Access Compliance Report

Public Rights-of-Way

(Curb Ramps)

Intersection ID: 10015635	Main Street: HARRIS_CORNERS_PY	Cross Street: N/A	Location: S
ADA ID: D55B0D81CD28	Ramp Type: PerpDiag	Initial Pass/Fail: Fail	Overall Compliance: No
Severity Score: 8.75			
Codes/Mitigation Info/Possible Solution		Field Measurements/Component Compliance

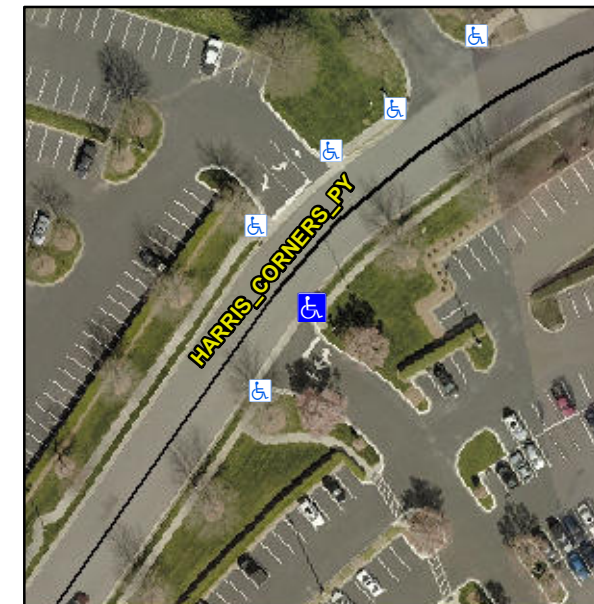
R304.5.1

Compliance	Description	Data	Compliance	Description	Data
N/A	Ramp Length (in)	66.0	Yes	Ramp Slope (%)	5.3
No	Ramp Width (in)	44.0	Yes	Ramp XSlope (%)	0.2
N/A	Flare Type LT	N/A	N/A	Flare Type RT	N/A
N/A	Flare Slope LT (%)	N/A	N/A	Flare Slope RT (%)	N/A
N/A	Flare Traversable LT?	N/A	N/A	Flare Traversable RT?	N/A
N/A	Landing Length (in)	N/A	N/A	DWS Provided?	N/A
N/A	Landing Width (in)	N/A	N/A	DWS Contrast?	N/A
N/A	Landing Slope (%)	N/A	N/A	DWS Length (in)	N/A
N/A	Landing X Slope (%)	N/A	N/A	DWS Full Width?	N/A
N/A	Landing Curb? (Y/N)	N/A	N/A	DWS Offset (in)	N/A
N/A	Shared Landing?	N/A			
N/A	Gutter Ponding?	N/A	N/A	Gutter Slope (%)	N/A
N/A	Gutter Lip Ht (in)	N/A	N/A	Gutter X Slope (%)	N/A
N/A	Painted X Walk1?	No	N/A	Painted X Walk2?	No
	X Walk 1 Direction	To NW		X Walk 2 Direction	To SW
N/A	X Walk 1 Width (in)	N/A	N/A	X Walk 2 Width (in)	N/A
	X Walk 1 Slope (%)	2.1		X Walk 2 Slope (%)	0.6
	X Walk 1 X Slope (%)	0.2		X Walk 2 X Slope (%)	1.3

Remove & Replace Curb Ramp With Two New Directional Ramps or Equivalent.
